Chaney Instrument Co.

Subject: Requesting Class II permissive change for FCC ID: RNEVN1TXCA1

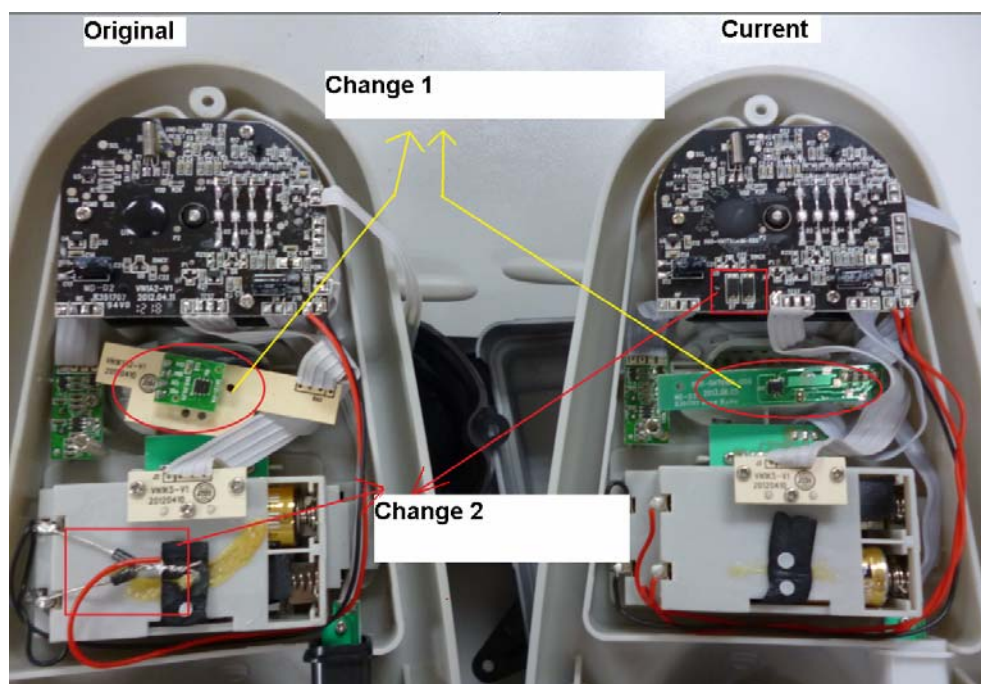
The Major change filed under this application is:

- 1) **A PCB board changes from welding to an adapter board to patching directly to another larger PCB board.**
- 2) **Two diodes change from soldered to a plug to patched to a PCB.**
